Ref. No. : ABB/4118/CLW/PE/0080

Subject: Request for approval of software version 55 in redesign Traction Converter in P7,G9 & P5 loco .

Prepared	Vaibhav Tripathi	11.06.2024	Project	CLW 3-Phase Locomotives	No of pages 2	
Reviewed	Karthick Gunasekaran	12.06.2024	Title	Change note for Software Ver-55		
Approved	Ramu S	12.06.2024	Converter	Bordline® CC1500 AC 25kV M2300 004 B01		
Department	MOTR					
 ABB India Ltd.			Document No.	Language	Rev.	Page
			2UDB271271 ZAB 937	en	-	1

Figure 2: Loco No. 30654 SR -2 background data

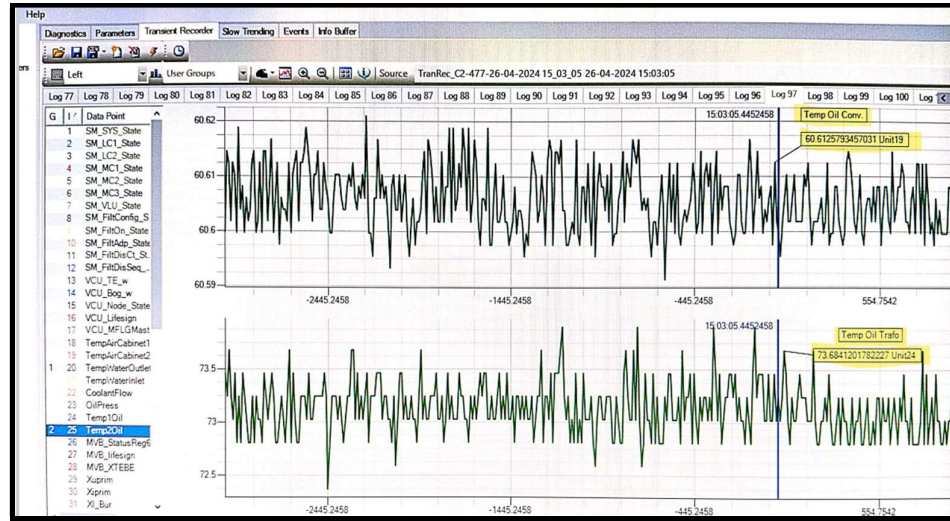
Background data of reported locomotives at the instance of fault checked and found SR coolant temperature breaching the limit while Transformer temperature found within the limit (Power reduction starts at 80 °C).

Fig 4: ABB traction Converter Cooling System

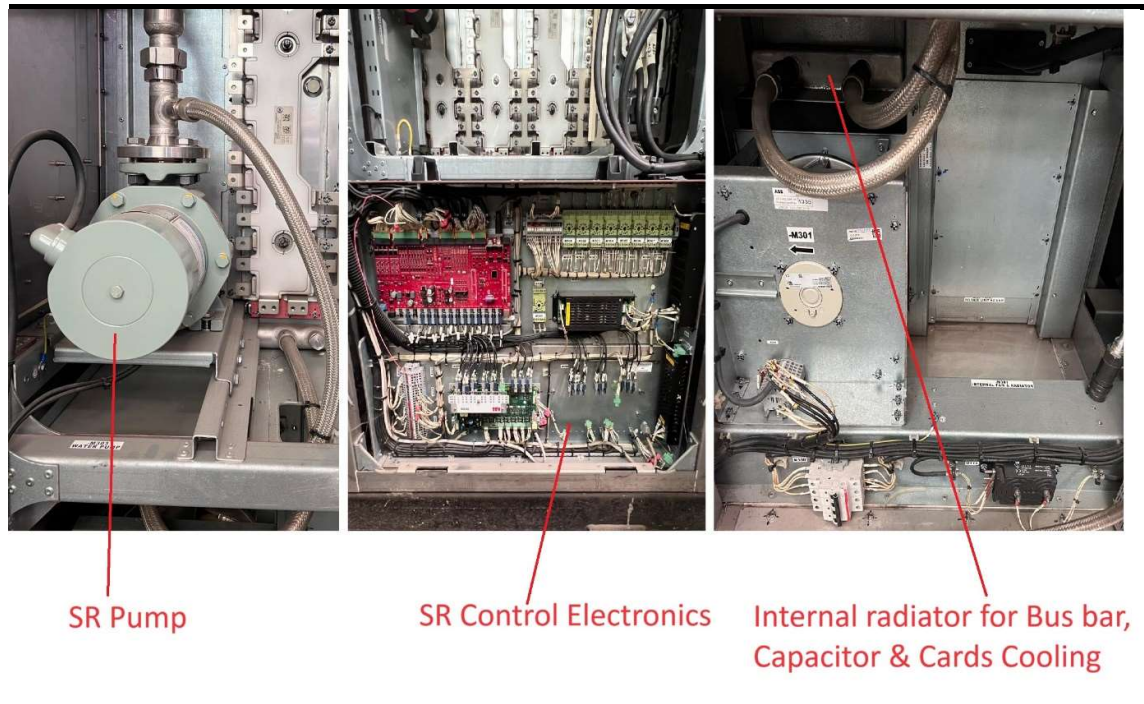
ABB composite traction converter has **unique design** in which complete traction converter is sealed and **same coolant is used in two small radiators (one in case of standalone traction converter)**. These are mounted inside traction converter to keep temperature of control electronics and traction converter within limit.

In ABB make traction converter as coolant is used for cooling of additional equipment other than power modules also, its temperature will rise more than in other make traction converter. This factor also contributes in more fault messages in ABB make traction converter.

3. Traction converter cooling system adopted in ABB traction converter need to be reviewed. Machine room blower cooling and churning fan cooling like other make traction converter can be used in ABB traction converter also.
This will reduce load on coolant-based cooling of traction converter and there will be lesser rise in coolant temperature.

Fig 6: Power reduction logic for transformer oil temperature

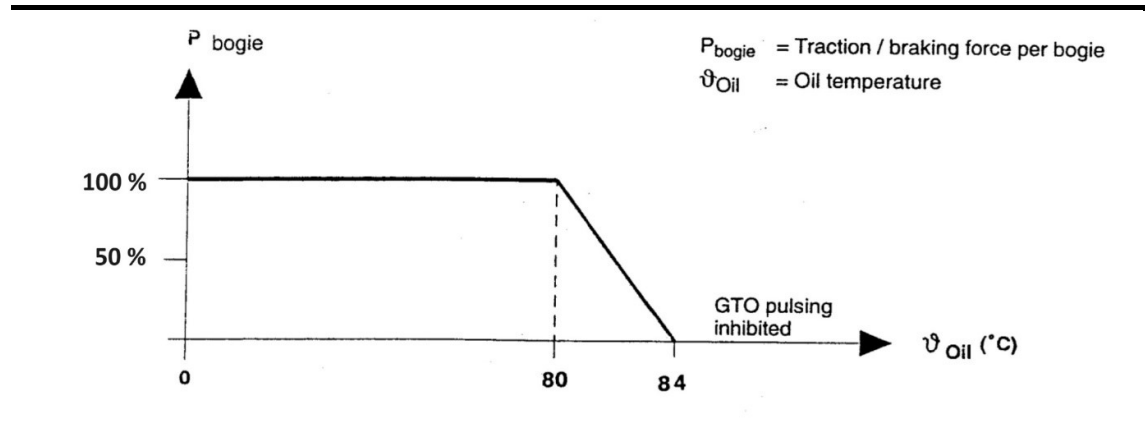
In original design of 3 phase locomotive, there was generation of priority II fault 'Power reduction Conv coolant temp > Limit' whenever coolant/transformer temperature crosses the defined limit. Logic defined in GTO locomotive is given below:

However, **In ABB traction converter there is no message related power reduction comes, only priority 1 fault comes when ever coolant/transformer temperature crosses the upper limit. In this bogie gets isolated or power fails without any warning to Loco crew.**

2. **Power reduction messages should be generated by traction converter.**
It will act as early warning for Crew/TLC before isolation of traction bogie or complete power. It will also improve preventive maintenance and reliability of ABB make traction converter.
